## ADDENDUM NO. 4

### GRANGER-HUNTER IMPROVEMENT DISTRICT, UTAH ANDERSON WATER TREATMENT PLANT PROJECT

December 3, 2024

DRAWING:  
**LP-101**

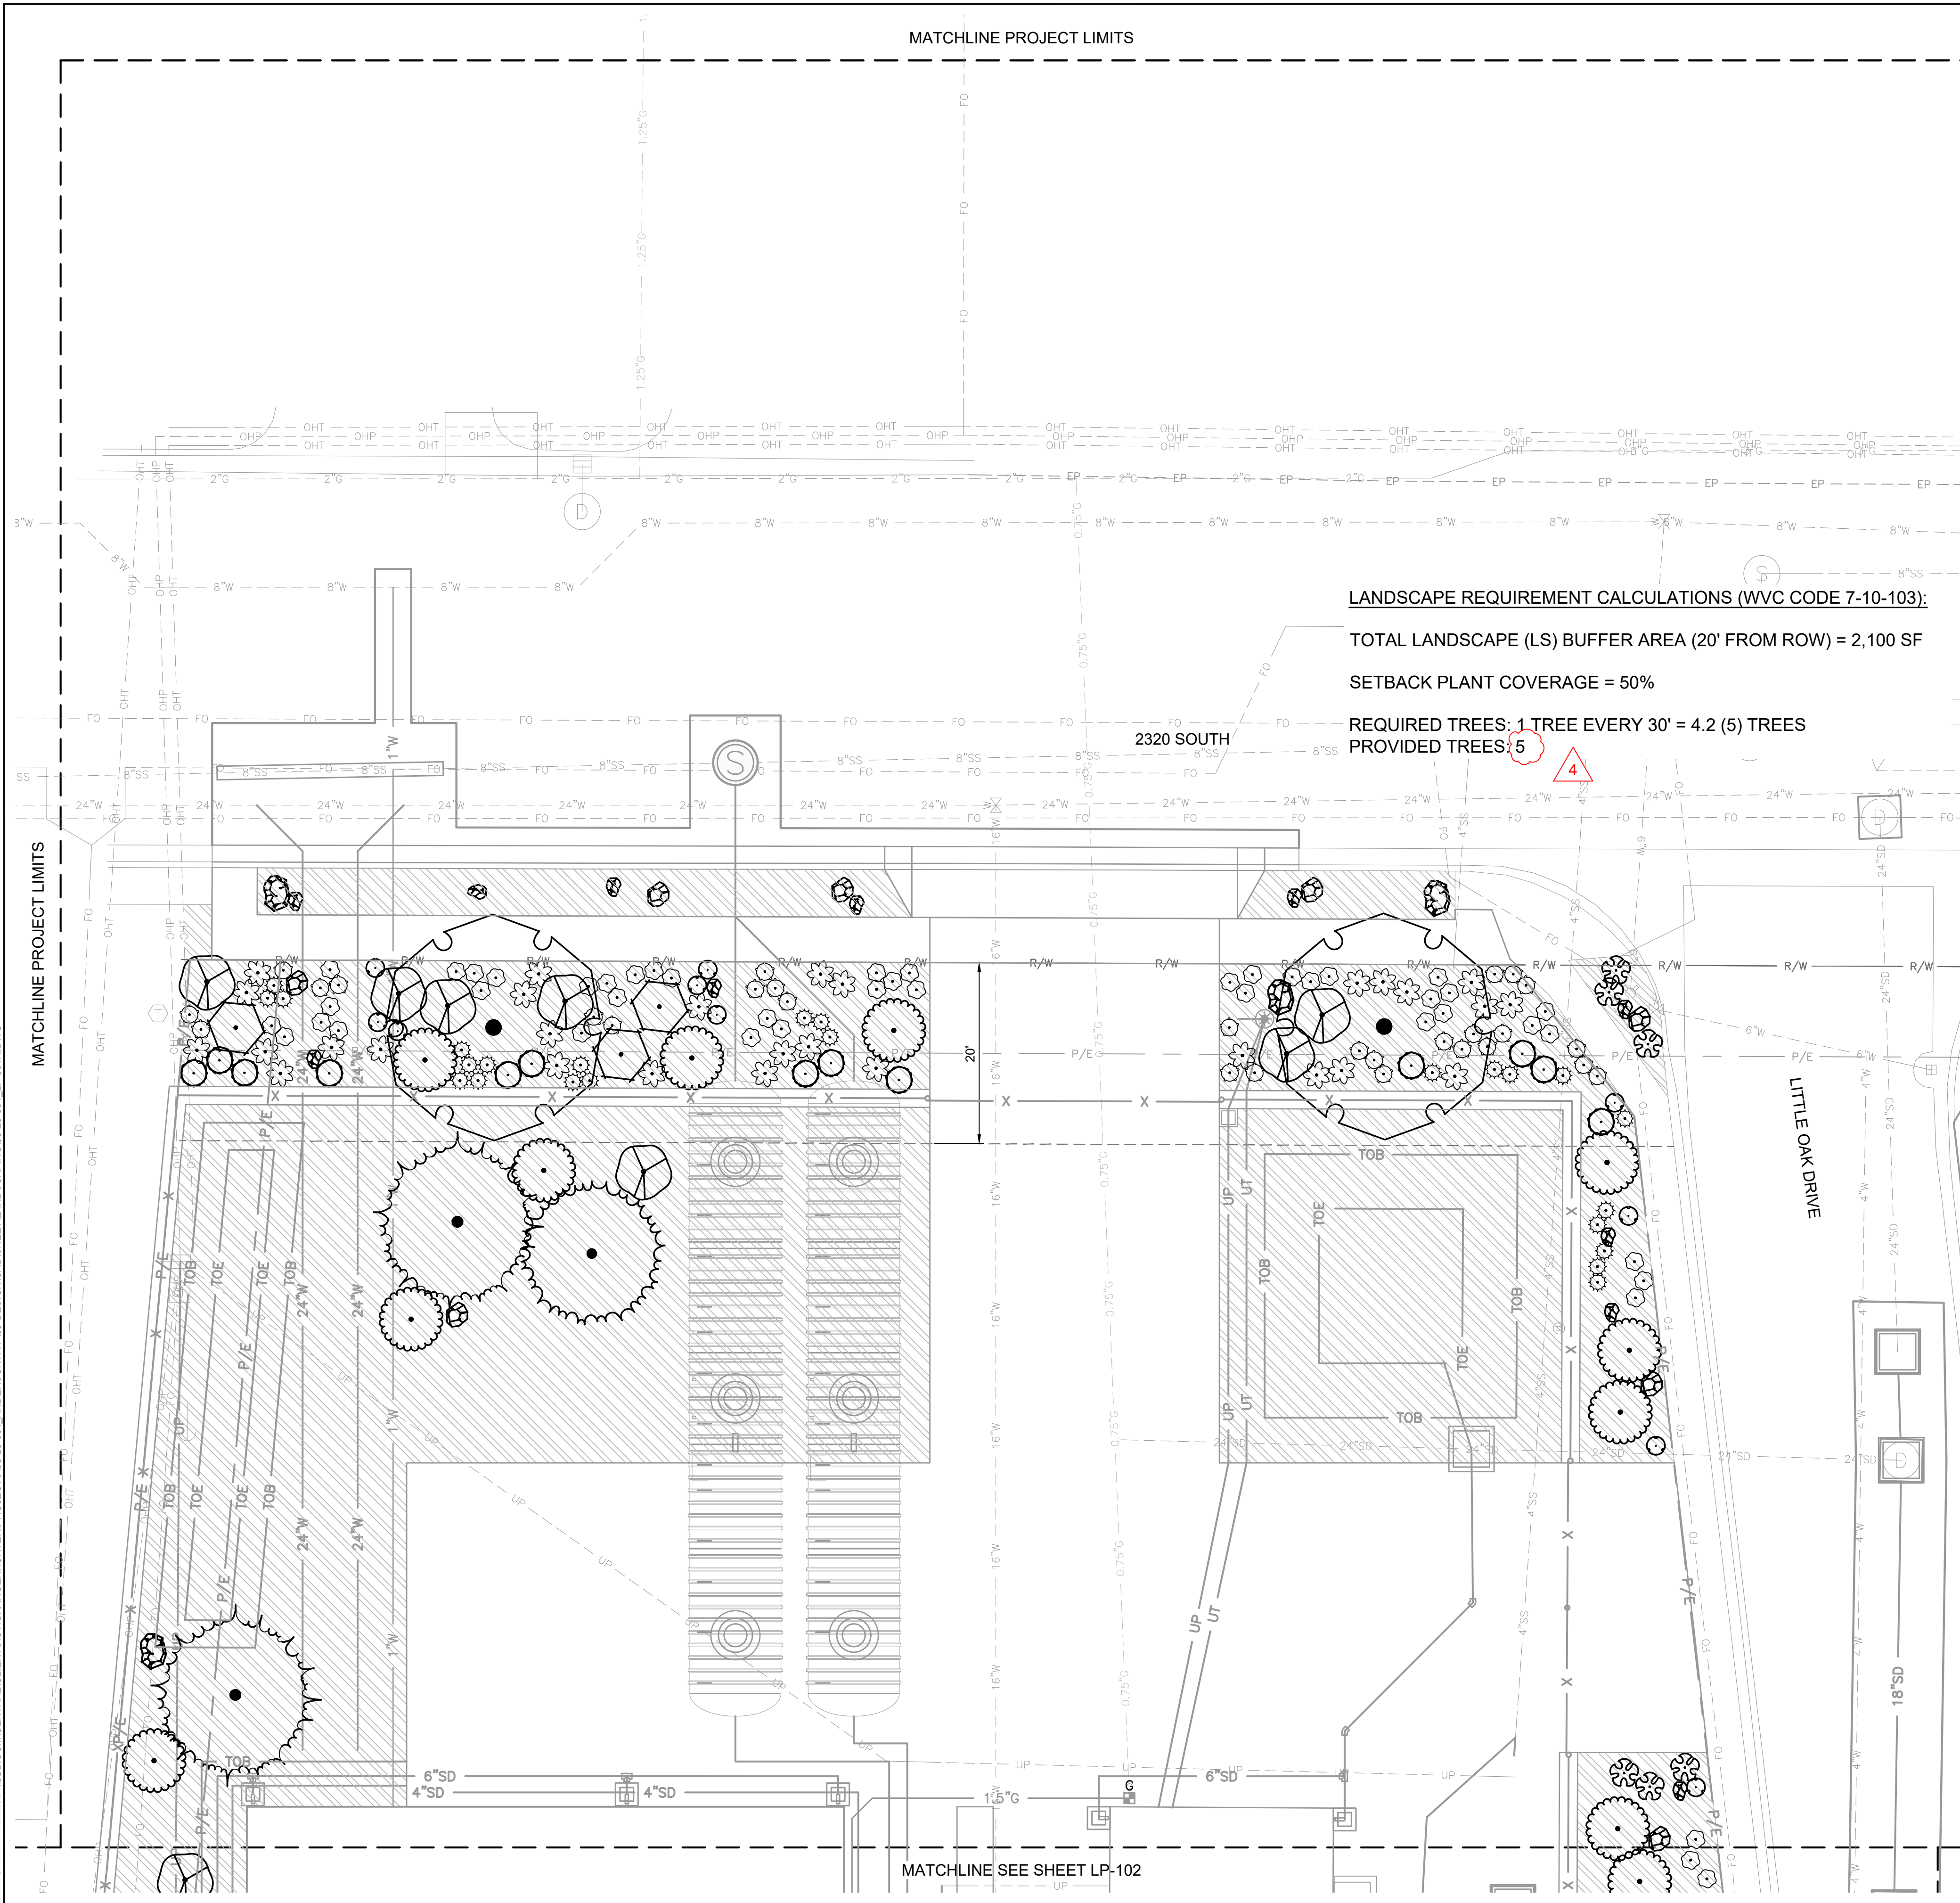
1. LP-101: Update to the "Landscape Requirement Calculations" table to show the correct number of trees provided (5) not (4).
2. LI-102: Revisions to the irrigation design in order to maintain active irrigation for the Red Oaks Village HOA during construction, and entails preserving an existing point of connection and back flow preventor, replacement of a section of irrigation mainline, and installation of a new valve to irrigation the small lawn areas adjacent to the new parking lot.
3. E-003: Add to the fixture schedule the following:
